**City of Portland, Maine - Building or Use Permit Application**

**Proposed Project Description:**  
Single Family Dwelling w/ attached garage

ONE AND TWO FAMILY	PLAN REVIEW	CHECKLIST
Soil type/Presumptive Load Value (Table R401.4.1)		
Component	Submitted Plan	Findings/Revisions/Dates
<b>STRUCTURAL</b>		
Footing Dimensions/Depth (Table R403.1 & R403.1(1), (Section R403.1 & R403.1.4.1)	OK—	
① Foundation Drainage, Fabric, Damp proofing (Section R405 & R406)	need fabric	OK
Ventilation/Access (Section R408.1 & R408.3) Crawls Space ONLY	N/A	
Anchor Bolts/Straps, spacing (Section R403.1.6)	1/2" @ 6" OC	
Lally Column Type (Section R407)	3 - 1 3/4" x 9 1/2" LVL'S	
Girder & Header Spans (Table R 502.5(2))		
Built-up Wood Center Girder Dimension/Type	-- "	
Sill/Band Joist Type & Dimensions	2x6 PT	
First Floor Joist Species Dimensions and Spacing (Table R502.3.1(1) & Table R502.3.1(2))	TSI	
Second Floor Joist Species Dimensions and Spacing (Table R502.3.1(1) & Table R502.3.1(2),)	" "	
Attic or additional Floor Joist Species Dimensions and Spacing (Table R802.4(1) and	2x8 Chng Joists	OK

The following are intended to clarify the questions on the plan review sheet for the proposed residence a

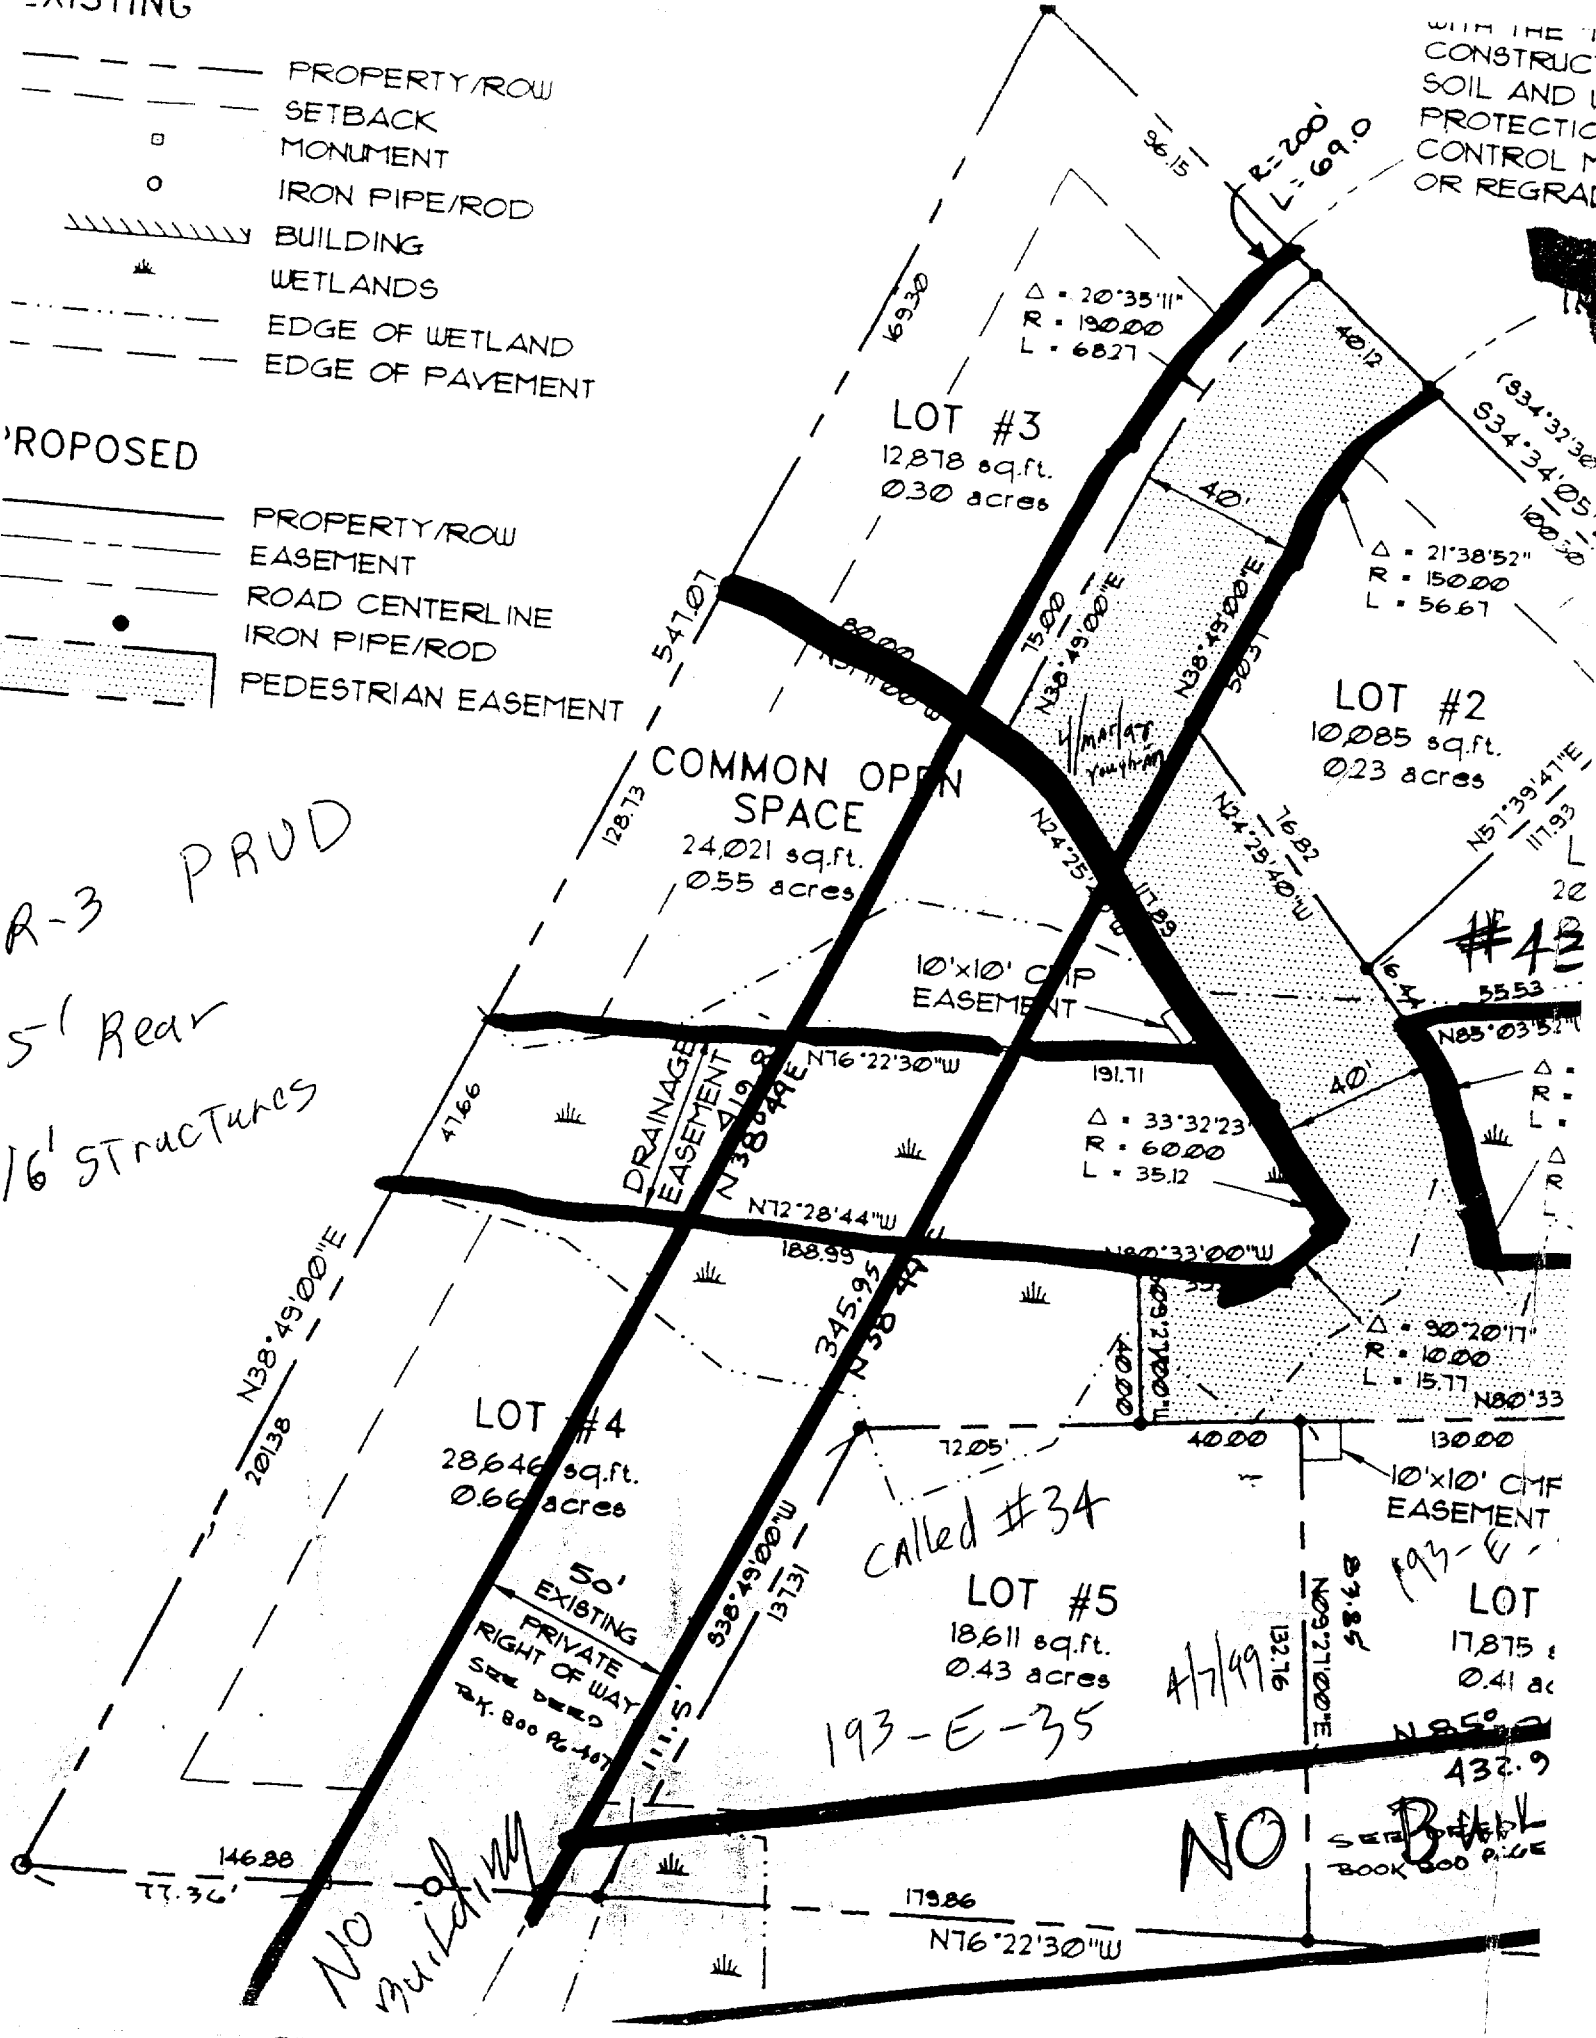
Street Frontage: ~~30'~~ 40' min - 40' approved on site plan

Max. Height: 35' - 35' from absolute lowest (garage) to highest K100 ft  
The average grade is measure to 1/2 pt well under 35'

Max. Length of Bldg (with/without attached garage(s): 140' max - 90' scaled

Min. Setbacks from External Subdivision Property Lines: 25' min - 28' scaled

Be sure they do not Bld on the R.O.W  
in front  
Blasting req.
